SUBJECT: Preliminary & Final Major Site Plan w/ Variance Application No. SP- 8/23  
**Tricone Engineers, Inc.**, Grovers Mill Road  
Tax Map Page 42.07, Block 4201.01, Lot 33.03

DATE: June 9, 2025

**Re:** Tricone  
Preliminary and Final Major Site Plan  
Block 4201.01 Lot 33.03  
Grover's Mill Road & Mall Access Road  
AT-4 (Apartment and Townhouse 4) Zoning District

**SUBJECT:** Grovers Mill Residences, Grovers Mill Road & Mall Access Drive  
Preliminary & Final Major Site Plan, SP-8/23  
Planning Board Memorandum #2  
Lawrence Township, Mercer County, New Jersey  
Tax Map page 42.07, Block 4201; Lot: 33.03

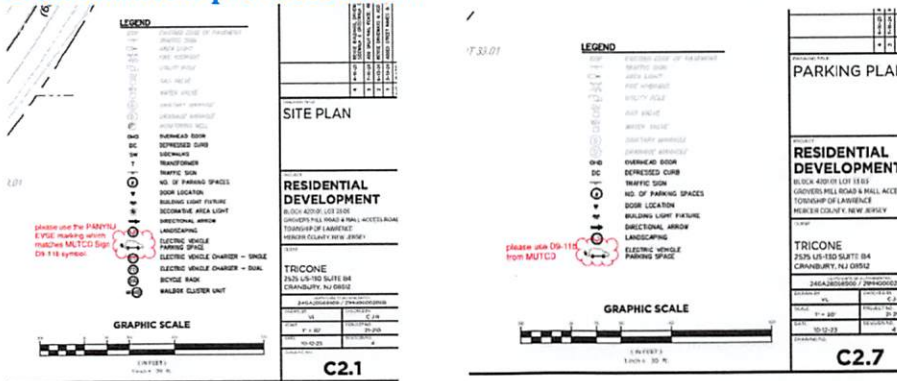
3. The ADA signs shown on sheet C2.1 are labeled incorrectly, which must be corrected. Moreover, the mounting order of those signs should also be shown correctly. The R7-8 sign (ADA Accessible Reserved Parking Sign) should be mounted at the top, R7-8aP (Van Accessible Plaque) in the middle (when used) and R(NJ)7-8A New Jersey Penalty Plate at the bottom. **Comment Open. The revised site plan still demonstrates incorrect ADA signs in the Traffic Sign Legend on drawing C2.1 and C2.7. The relevant screenshot from the revised site plan is provided below.**

Ⓐ R7-8N (12"x18") **R7-8aP (12"x6")** **R(NJ)7-8A** ~~N-17 (10"x12")~~

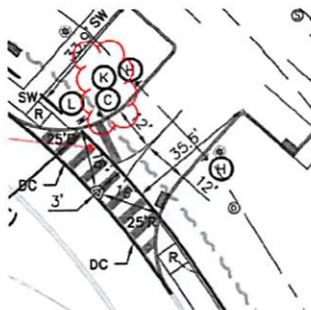
8. The Stop sign shown at the southern right-in-right-out driveway (sheet C2.1) is mounted incorrectly underneath the R3-2 sign. The Stop sign is always mounted at the top of all mounted signs. **Comment Open. The revised plan still demonstrates incorrect mounting of the signs on drawing C2.1. The relevant screenshot from the revised site plan is provided below**

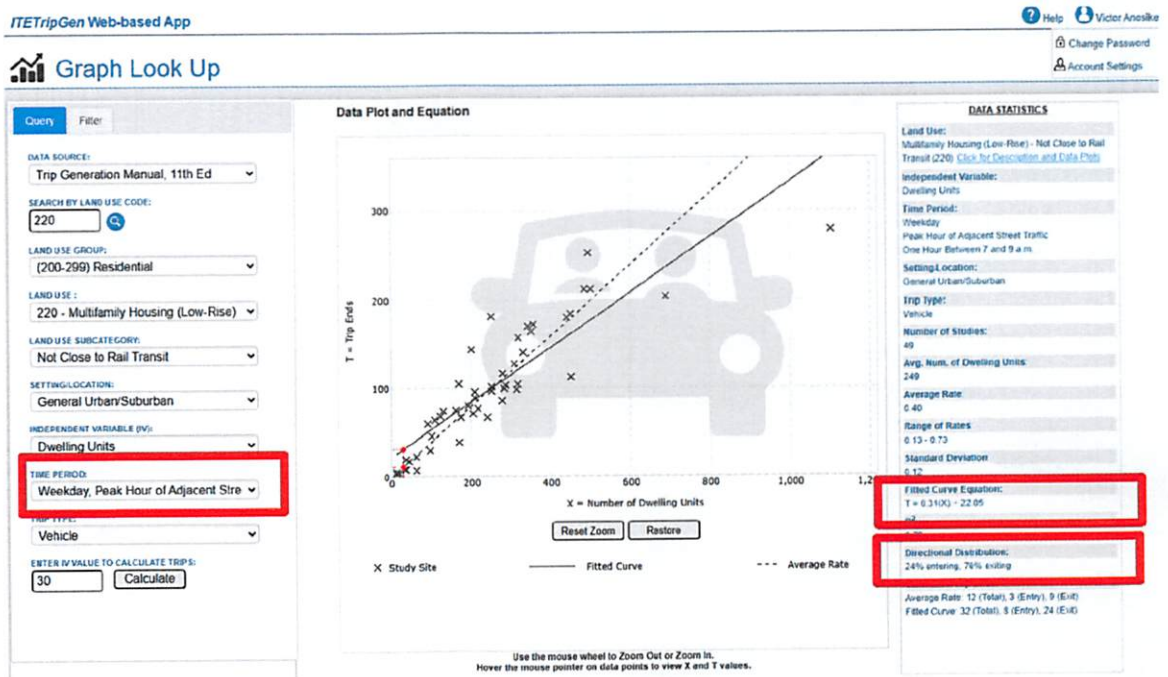
9. The Traffic Impact Study (TIS) was developed based on incorrect calculation of the site generated trips. Details are described below:

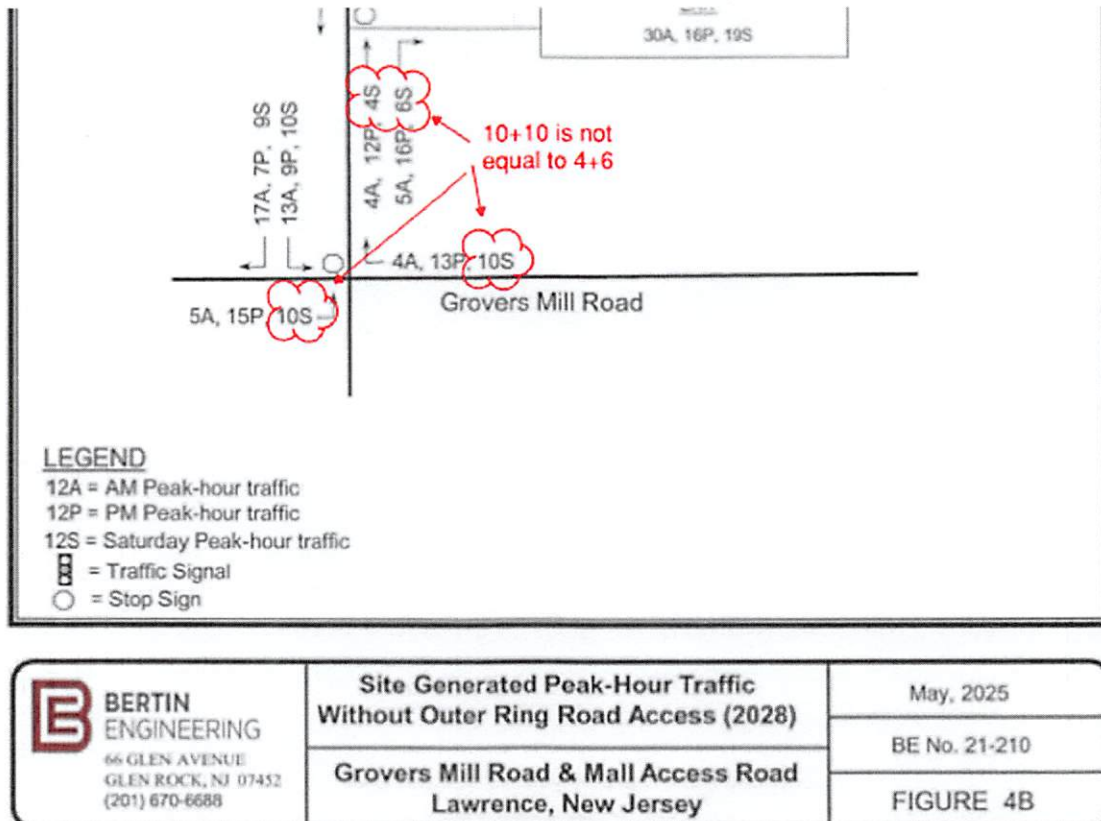
- a. The TIS incorrectly assumed '*AM/PM Peak Hour Generator*' category to calculate the site generated trips. In the Traffic Engineering practice, to calculate the site generated traffic for any TIS, the assumption should always be to use the '*Peak Hour of Adjacent Street Traffic*' category, not the '*Peak Hour Generator*' category. The peak demand for *Peak Hour Generator* may not overlap at the same time with the *Adjacent Street Peak Hour*. As such, the calculated site generated traffic using the '*Peak Hour Generator*' category will be inaccurate. The purpose of the TIS is to evaluate the operating conditions of the Adjacent Street Traffic during the peak hour condition for the proposed project. It is to be noted that our calculation shows the '*Peak Hour of Adjacent Street*' category results much higher site generated traffic during both AM/PM peak hours compared to the numbers shown in Section 8.1 of the TIS. **Comment Open. The revised Traffic Study dated May 1, 2025, still shows incorrect trip generation values on Page 8. The revised study still assumes incorrect 'time period - Peak Hour Generator' instead of the correct option known as 'weekday peak hour of adjacent street'. The trip generation calculation for both AM and PM peak hours were performed incorrectly and must be revised. As such, all future year Build condition traffic analysis results are flawed and must be revised. A screenshot showing the correct AM time period is provided below from ITE website/manual. Traffic study should use the fitted curve equation as well as the entering/exiting traffic % for AM analysis. A similar approach should also be followed for 'weekday PM peak hour adjacent street' analysis to calculate trip generation, entering/exiting % and fitted curve equation.**
